TRANS/WP.29/GRSP/2000/2  
23 February 2000

World Forum for Harmonization of Vehicle Regulations (WP.29)

PROPOSAL FOR DRAFT AMENDMENTS TO REGULATION No. 44  
(Child restraint systems)

Transmitted by the Expert from Sweden

Figure 2

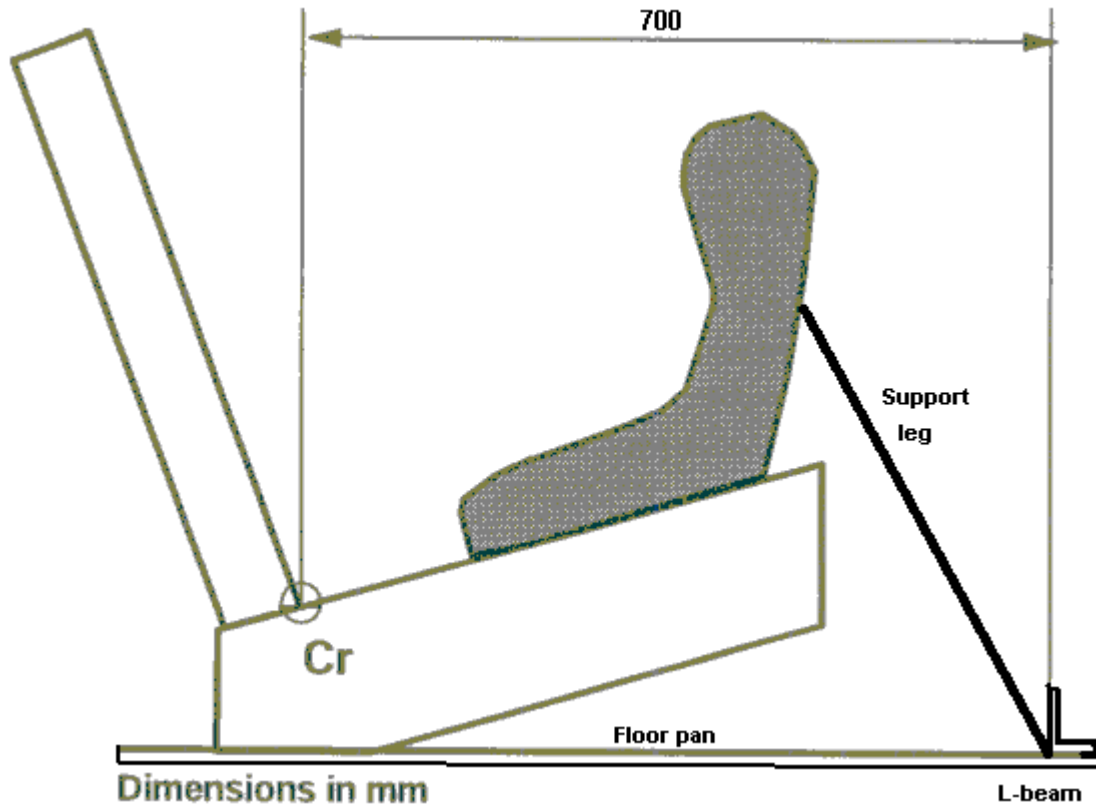
1.2.5. A beam of metal L-profile shall be fitted transversely to the trolley floor pan 700 mm ahead of line Cr in order to act as a rest for the supporting leg and simulate the front seat rear structure. The flat surface of the L-profile shall be facing the child restraint system. (See figure 2 to this annex.)

The L-profile beam shall have a length of 500 mm  $\pm$  0.5 mm, width of 40 mm  $\pm$  0.5 mm, height of 40 mm  $\pm$  0.5 mm, and a minimum thickness of 5 mm.

The L-profile beam shall be rigidly welded or bolted to the trolley floor pan. If bolts are used, this shall be done with at least 3 M10 bolts.
